**PCN#20150324000
New trays for 12x12x1.4 Select LQFP Devices
Final Change Notification**

PCN Number:	20150324000	PCN Date:	03/25/2015
Title:	New trays for 12x12x1.4 Select LQFP Devices		
Customer Contact:	PCN Manager	Dept:	Quality Services
Proposed 1st Ship Date:	09/25/2015	Estimated Sample Availability:	03/11/2014
Change Type:			
<input type="checkbox"/> Assembly Site	<input type="checkbox"/> Assembly Process	<input type="checkbox"/> Assembly Materials	
<input type="checkbox"/> Design	<input type="checkbox"/> Electrical Specification	<input type="checkbox"/> Mechanical Specification	
<input type="checkbox"/> Test Site	<input checked="" type="checkbox"/> Packing/Shipping/Labeling	<input type="checkbox"/> Test Process	
<input type="checkbox"/> Wafer Bump Site	<input type="checkbox"/> Wafer Bump Material	<input type="checkbox"/> Wafer Bump Process	
<input type="checkbox"/> Wafer Fab Site	<input type="checkbox"/> Wafer Fab Materials	<input type="checkbox"/> Wafer Fab Process	
	<input type="checkbox"/> Part number change

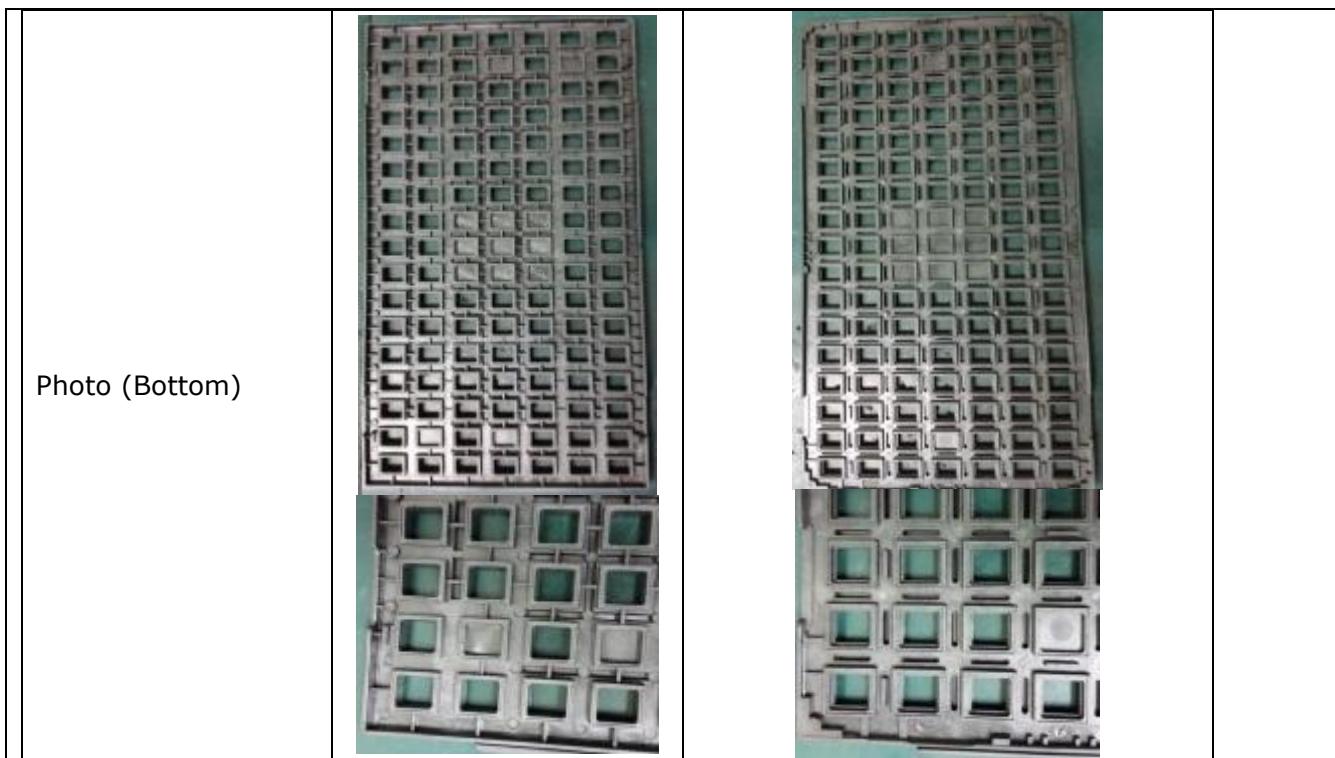
Texas Instruments is pleased to announce the qualification of a new improved tray for the devices listed below. A comparison summary is below:

What	From	To
Stock #/Supplier	4046035/Peak	4221976/Daewon
Weight	162g	155g
Temperature Rating	180C	150C
Color	Grayish-Black	Black
Raw Material	Polyether Sulfone (PES)	Modified Poly Phenylene Oxide (MPPO)
Pedestal Design	Slope - Chamfer	Slope - Fillet
Photo (Top)
